SUBJECT: REQUEST FOR ADDITIONAL INFORMATION REGARDING CENPD-137,  
SUPPLEMENT 2-P

## REQUEST FOR ADDITIONAL INFORMATION CENPD-137, Supplement 2-P

**Subject:** Supplementary Information to FTI's Response to NRC's Request for Additional Information on BAW-10168, Volume II, Revision 2, October 1992; RSG LOCA - BWNT Loss-of-Coolant Accident Evaluation Model for Recirculating Steam Generator Plants.

700 seconds

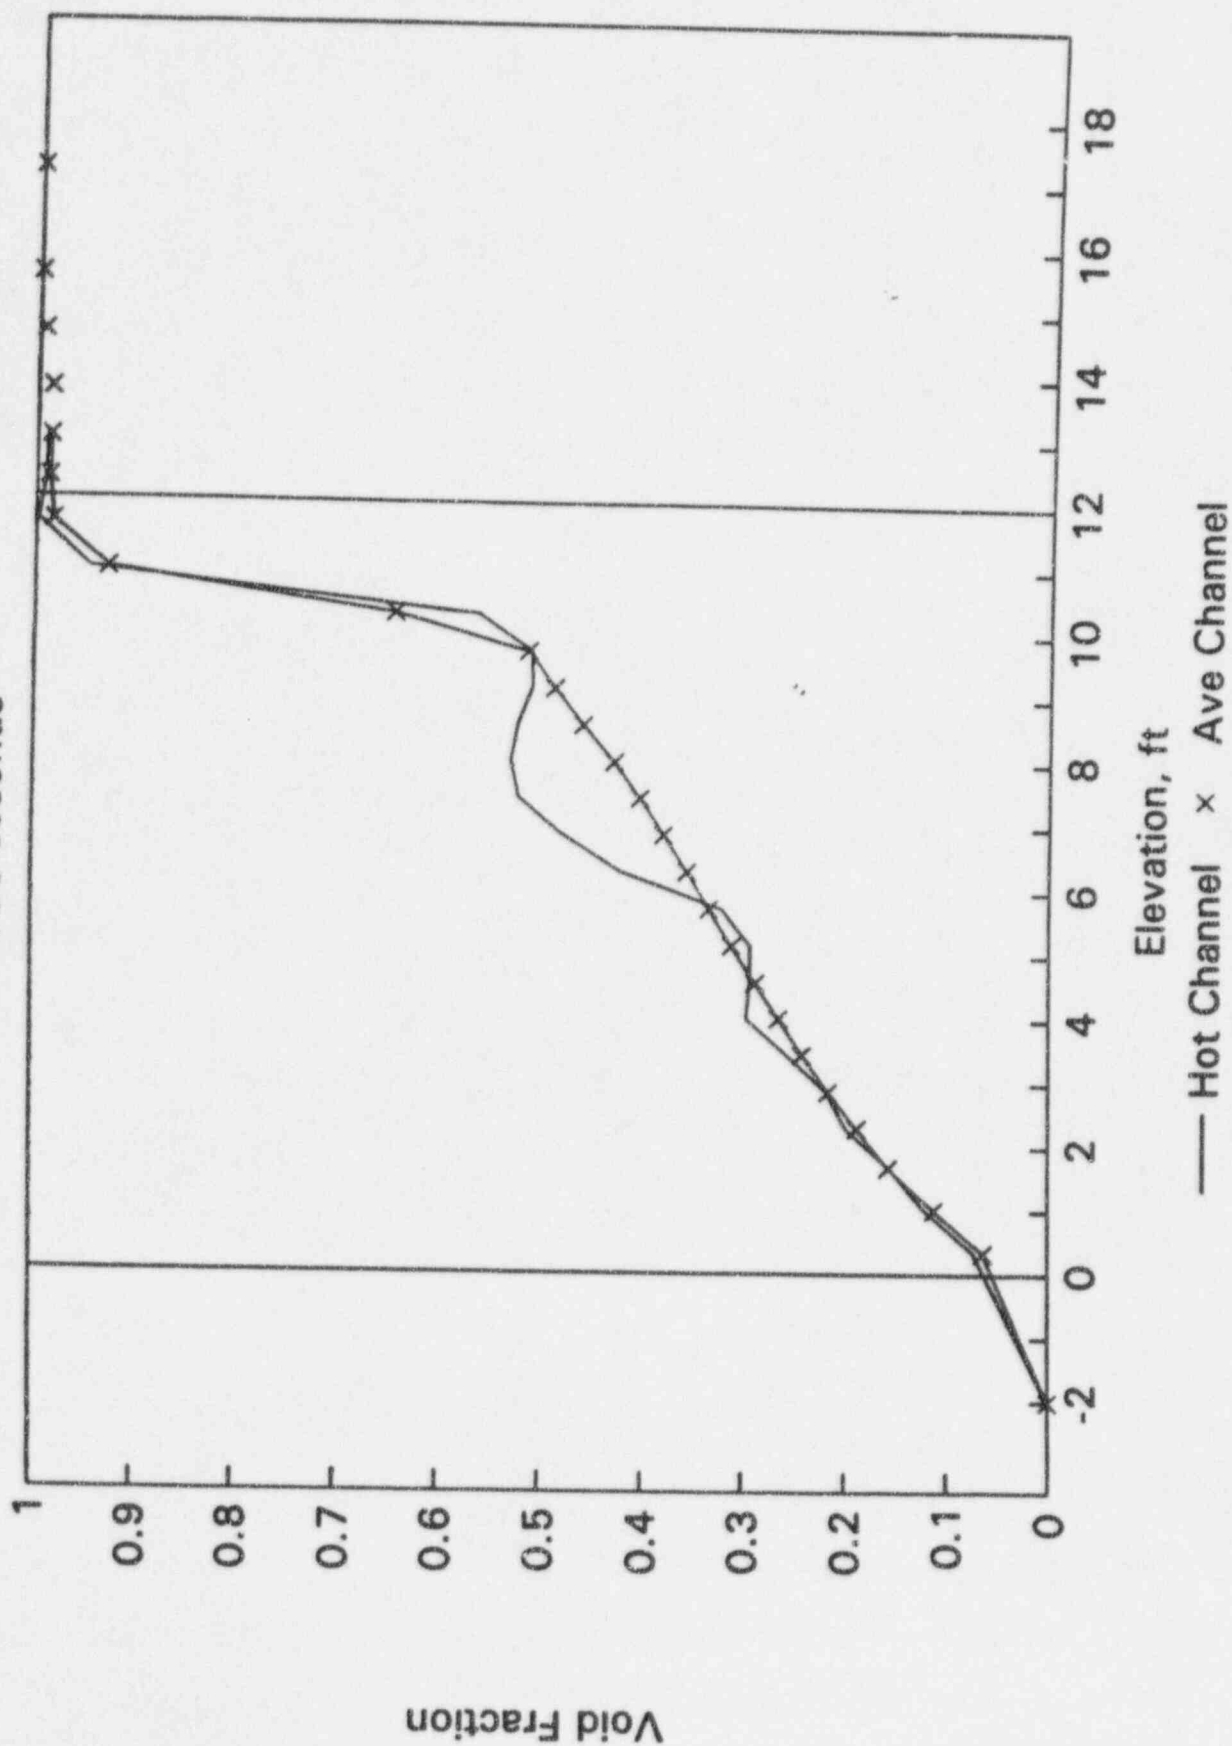
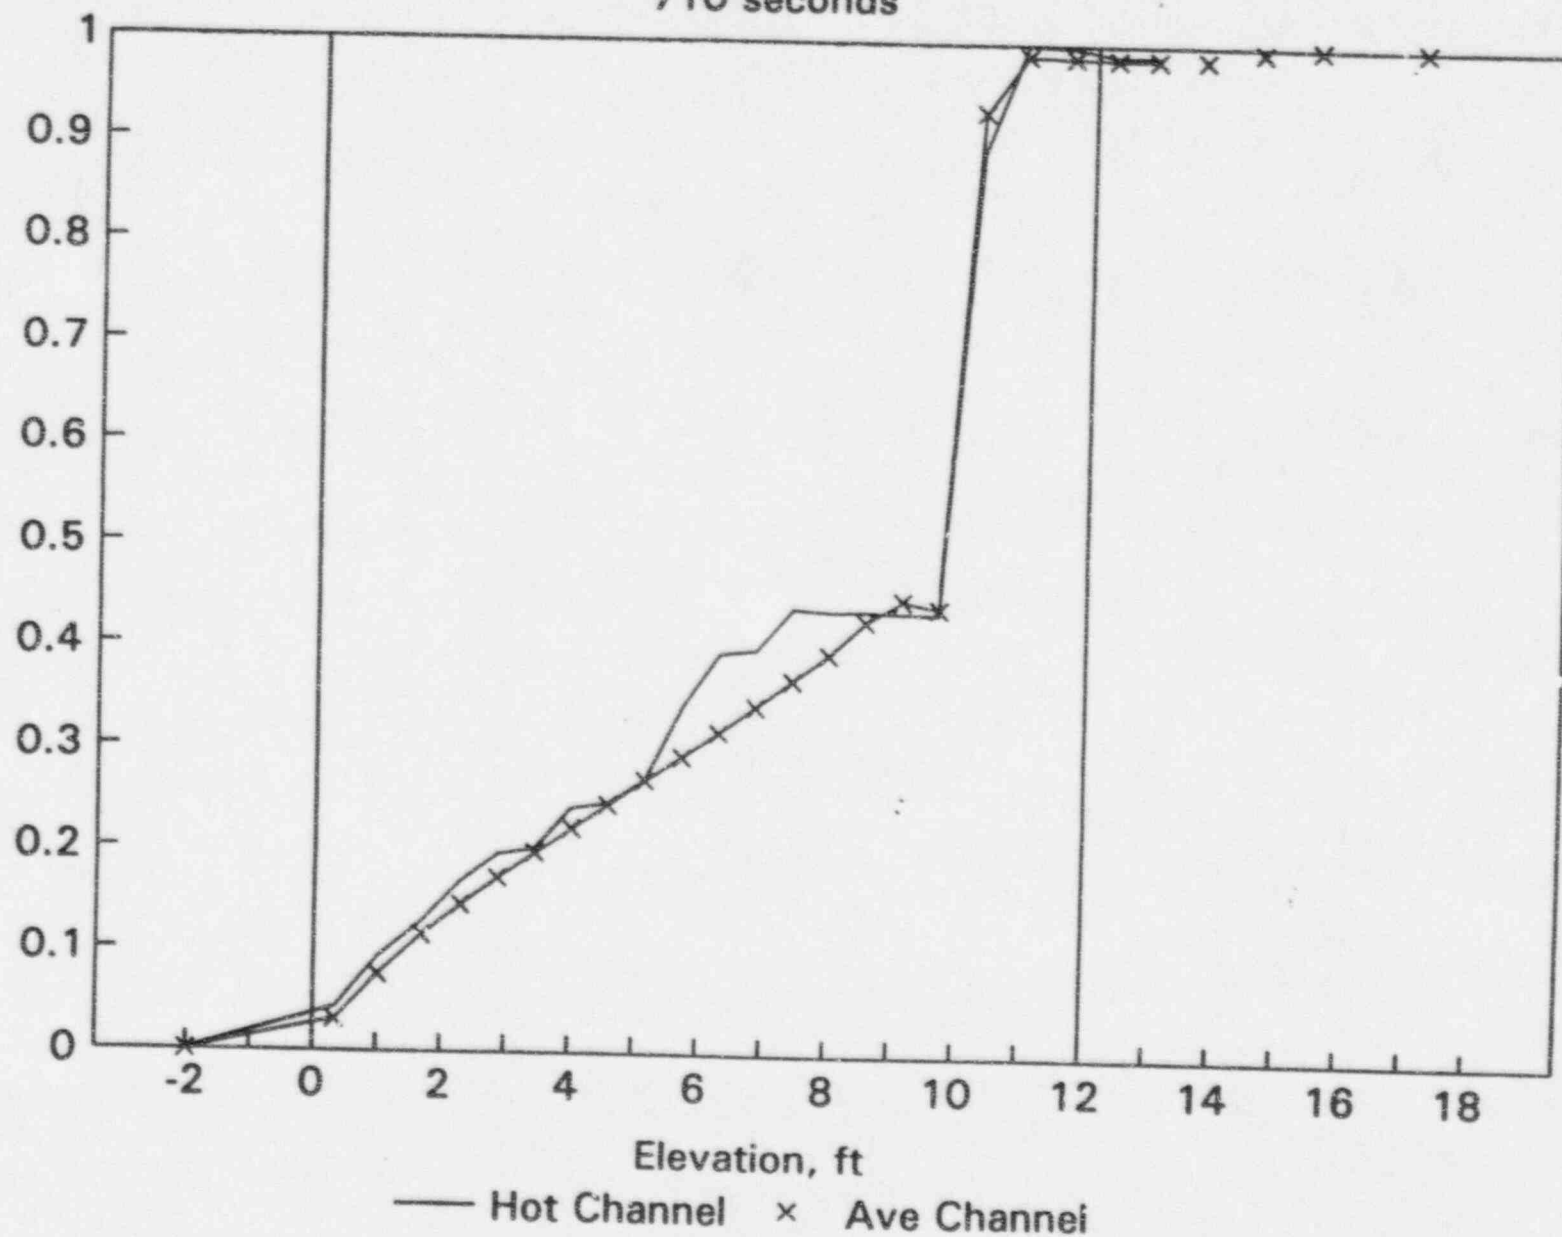
That the hot channel and average channel mixture heights evolve reasonably during a core uncover can be observed in the attached figures. These figures display the axial void distributions of the hot and average channels as they developed for a 3-inch pump discharge break in a Westinghouse-designed 4-loop plant over the loop seal clearing period. The figures display void fraction versus axial core elevation from the lower plenum to the upper plenum at the elevation of the outlet nozzles. Each void fraction is displayed axially at the center of the volume from which it is taken and is connected to the void fraction of the adjacent nodes by a straight line. If not recognized, this technique can introduce some confusion, as occurs between the lower plenum and the core. The lower plenum is or is nearly liquid solid throughout the time period of these graphs, but the linear connection to the first core volume, which is legitimately voided, produces a visual impression that the lower plenum contains steam as the bottom of the core is approached. In truth there is a step change in void content between the lower plenum and the core. The same recognition should be made in reviewing the upper plenum void fractions. This, in part, is the reason that the channels, except for the lower plenum to the core, are displayed with connecting lines while the upper plenum volumes are displayed as points. The time at which the figure is captured is displayed just above the figure border. Within the upper plenum, the upper most value is at the elevation of the center of the core outlet nozzles. This volume spans the height of the outlet nozzles. The next lower volume is entirely below the span of the hot leg piping.

Loop seal clearing for the case shown in the figures occurs at approximately 715 seconds. The graphs display the core elevation head/mixture height as the necessary head to clear the loop seal develops on the approach to loop seal clearing and as the core refills after clearing. Graphs are provided at 640, 660, 680, 690, 700, 710, 715, 720, and 800 seconds. By 640 seconds, the clearing process has initiated and the core mixture level has fallen below the nozzle belt as indicated by the void fraction in the upper most volumes. (The upper volume represents the portion of the upper plenum adjacent to the outlet nozzles.) The core is still covered with mixture and the depressed void fraction at the exit to the hot channel can be observed. It can also be

observed that the correspondence in void content between the average channel and the hot channel is quite good. Deviations occur, but the general trend is a slightly higher void content in the hot channel. There is no indication that the lower void content of the hot channel exit volume has propagated downward. By 660 seconds, more of the upper plenum is voided, but the core is still covered and the core void distributions remain reasonable. At 680 seconds, the columns representing the hot and average channels are starting to void. The upper plenum is essentially 100 percent voided. The core heated regions are still covered since the high voiding has not penetrated below the non-heated regions of the fuel assemblies. By this time, before any core heatup, the void fraction for the hot assembly upper region has evolved into agreement with that of the average channel. At 690 seconds, the heated regions of the hot and average channels have started to uncover. Loop seal clearing is now about 25 seconds away. Because the core outlet void fraction is at 90 percent, the cladding temperatures remain near saturation.

At 700 seconds, the two upper volumes of the heated core are showing substantial voiding and the very top heated node may be experiencing some heatup. For the limited uncover apparent here, mist entrainment from the mixture may be sufficient to prevent core heatup. The hot and average mixture levels are in agreement as the uncover proceeds. At 710 seconds, the mixture has fallen to its lowest level during loop seal clearing. The hot and average channel mixture levels remain in agreement with the hot channel slightly more voided. At 715 seconds, the loop seal for the broken loop has cleared and the downcomer and core levels are starting to equilibrate creating a core refill. By 720 seconds, the refill has progressed into the upper plenum. The void fraction at the very outlet of the hot channel is again depressed but that was not observed in the partial refill at 715 seconds. Thus, the predictions of the hot channel exit void fraction are consistent with the needs of the transient prediction, attaining the required degree of accuracy under conditions when core uncover is occurring or eminent. By 800 seconds, the refill is complete and the core boil down phase has been entered. As shown, the refill did not completely fill the vessel. The region just below the out nozzle remains at an elevated void content and the upper plenum at the outlet nozzle elevation is completely voided.

In conclusion, core modeling has been arranged to provide for hot and average channel effects. Specific provisions have been incorporated into the EM to achieve conservative predictions of cladding temperature (crossflow resistance for the upper half of the core). The modeling works well during core uncover as evidenced by the agreement between the hot and average channel mixture levels. Although a modeling factor does lead to an apparently inconsistent void fraction in an upper unheated volume of the hot channel during those phases of the SBLOCA transient when the upper plenum contains mixture, this difficulty is resolved as the core uncovers and is not present at any time that the calculation is predicting core uncover or calculating cladding temperature excursions. Therefore, the core modeling approach employed is appropriate for the calculation of small break LOCA simulations.
